ENGINEERING CHANGE REQUEST (ECR)

CUSTOMER DRAWING NO. D972118

DRAWING TITLE LIQO BSC CROSSBEAM WELDMENT

REVISION: FROM B TO C

HYTEC, INC.	
LIGO SSC CROSSBEAM WELDMENT	
D072118-1	D072118 0 1 of 1

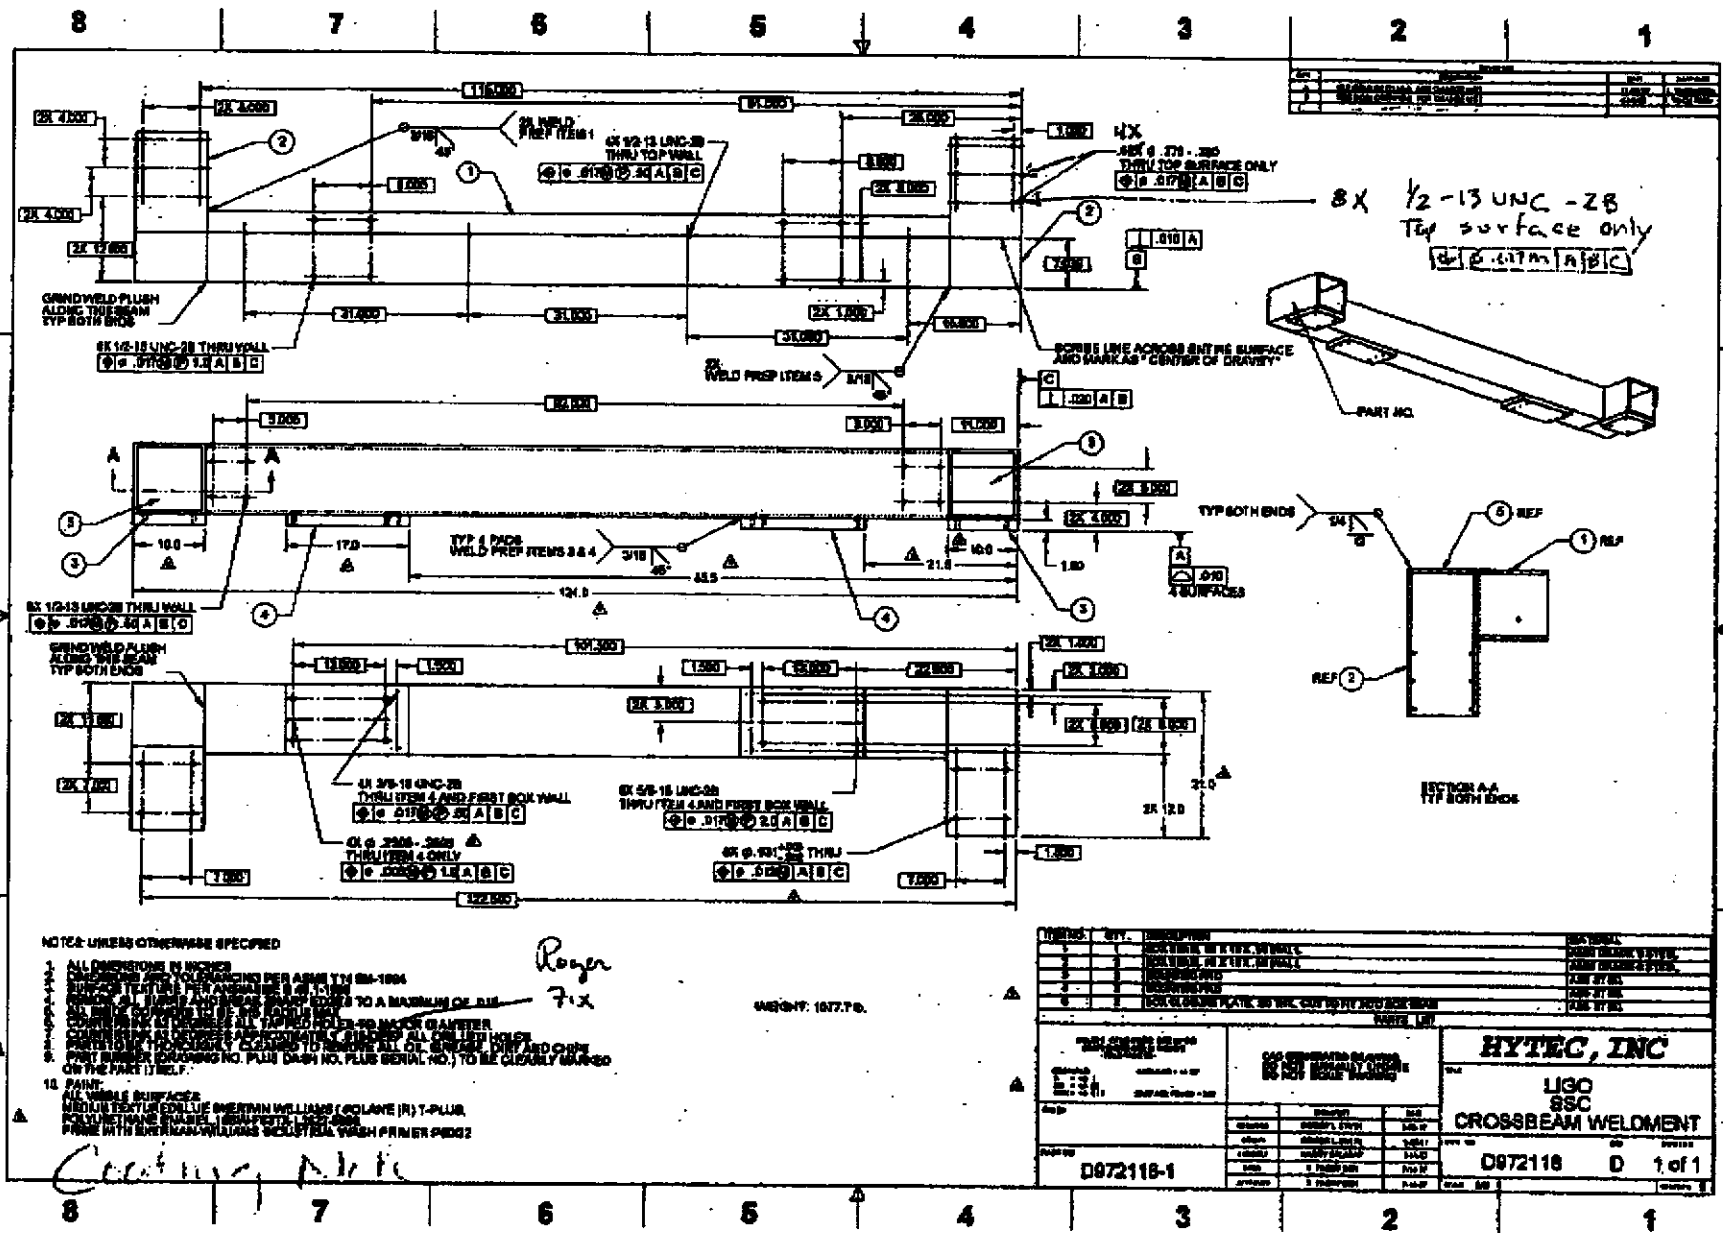
CHANGE 8 OF THE EXISTING 12 HOLES IN TOP
OF CROSSBEAM. HOLES ARE Ø.375-.380,

CHANGE TO 1/2-13UNC-2B SEE SKETCH

Add the coating call out to be applied to all unpainted

(2X) $\phi .375-.380$
THRU TOP
SURFACE ONLY

(8X)

$\frac{1}{2}$ -19UNC-2B
THRU TOP SURFACE ONLY

BOTH SIDES (ends)
